CITY PLAN COMMISSION Wednesday, April 27, 2022 Work Session 12:00 p.m. Public Hearing: 1:30 p.m.

STAFF INFORMATION REPORT FS-22-037
CPC: 04/27/22 Waiver Request

FS-22-037 <u>Diamond Creek Addition (Waiver Request)</u>: 3 One Family Detached Residential Lots. ETJ - Tarrant County.

Title: Diamond Creek Addition - Minor Plat for 6075

FINAL PLAT OF DIAMOND CREEK ADDITION LOTS 1, 2, AND 3 - BLOCK 1

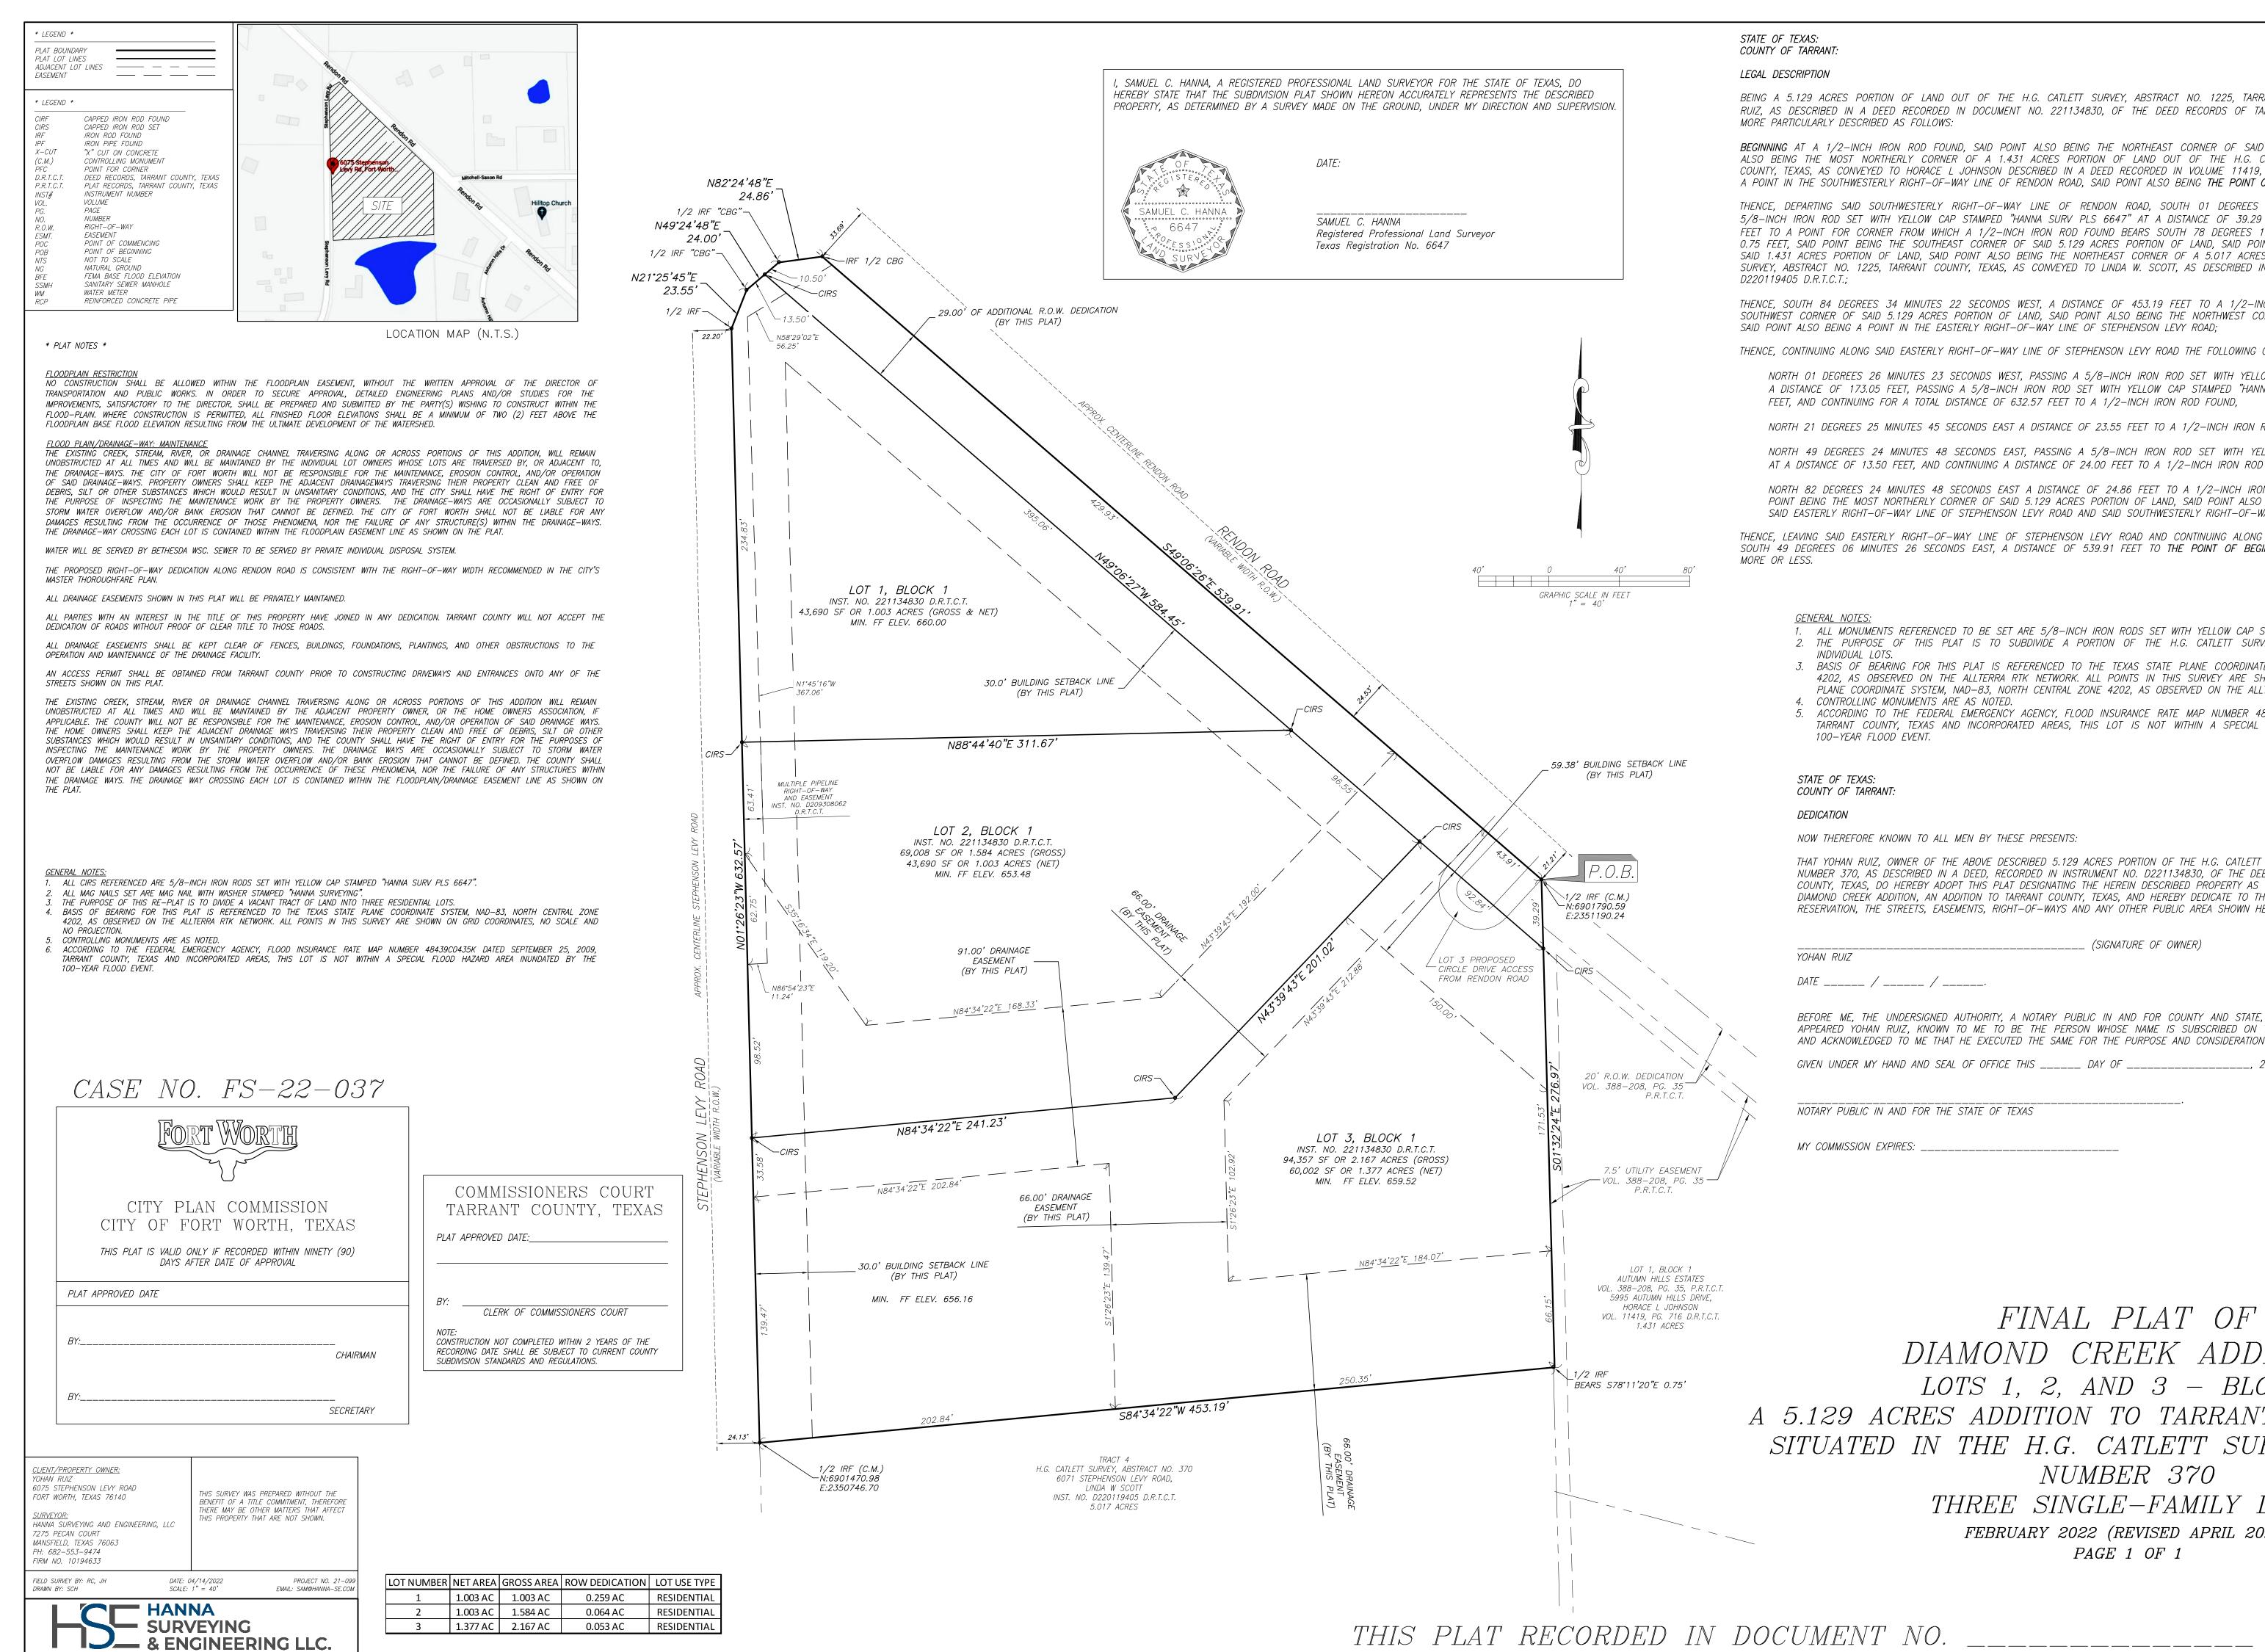
- Our department has reviewed the attached initial plat and recommends that the following comments be addressed before we can clear it:
- 1) (Cleared 4-20-22)The plat should include the most current versions of the Tarrant County Plat Approval Signature Block and the Tarrant County Standard Plat Notes, which can be downloaded from the County's Subdivision and Land Use Regulations (SLUR) web page (www.tarrantcounty.com/slur). [TC-SLUR-CHKL-LI-21, TC-SLUR-SEC-E2]

- 4)(UPDATE)The recording information shown in each lot should be removed. [TC-SLUR-CHKL-LI-17, TC-SLUR-SEC-E2] TAD and Tarrant County Clerk records indicate that deed recording instrument D221134830 is specific

- 5)(UPDATE)The tract to the east of this proposed subdivision is platted so this plat should show the proper adjacent right-of-way dedication. [TC-SLUR-CHKL-LI-9, TC-SLUR-SEC-E2] (Additional row for road dedication is not shown)

- 6)(Update) The existing width and centerline of the right-of-way for the adjacent County roads (Rendon Road and Stephenson Levy Road) should be identified along with the proper recording information., which is available from the County Clerk on-line. [TBPELS §138.85(3)(A), §138.85(3) (B), §138.85(3)(D)] [TC-SLUR-CHKL-LI-9, TC-SLUR-SEC-E2] (If assistance is needed contact Bob Viscome)

- 11)(Update) The Barnett Gathering line adjacent to Rendon Road should also be labeled and dimensioned along with its proper recording information. [TC-SLUR-CHKL-LI-8 and11, TC-SLUR-SEC-E2] 9If assistance is needed contact Bob Viscome)

ADDED 4-20-22 A) Consistent with the City's Final Plat Checklist, existing or proposed improvements such as driveways are typically not shown on a final plat. We request that the surveyor or City staff provide clarification to us about the addition of the circular driveway in Lot 3 of the plat. B) The 59-foot building setback line added to Lot 3 far exceeds the City's and the County's minimum setbacks. We request that the surveyor or City staff provide clarification to us about the need for this extended setback.

- 1. (Cleared 4-15-22)(FYI) Reference plat case number on the plat FS-22-037.
- 2. The Subdivision Ordinance [S.O., Section 31-103 (4)(c)] states that direct residential driveway access to individual one-family and two-family dwellings shall not be allowed on an arterial (Rendon Road). The City Plan Commission may grant a waiver if such lots are a minimum of 150 feet in width or greater at the building setback line and contain a circular access drive with approval by the City Traffic Engineer and egress per TPW design requirements. A waiver from the City Plan Commission would be required.

- TPW (Michael Arthaud, 817-392-6597, Michael. Arthaud@fortworthtexas.gov)
- 1. Show the dimensions of all existing or recorded streets, alleys, easements, railroad ROW, or other public ROW within or adjacent to the subdivision boundaries. The distance from the centerline of the existing roadway of the boundary street to the proposed property line shall be shown. Include all dedication information for all existing rights-of-way.

- 3. The project is adjacent to or includes an arterial identified on the MTP. The classification(s) for {Rendon Road} is {NCO-L2-TO-NTMS-P0-BOP (110')} which requires 2 lane(s) in each direction 10ft. sidewalks with a Standard Median (110ft.) in width.
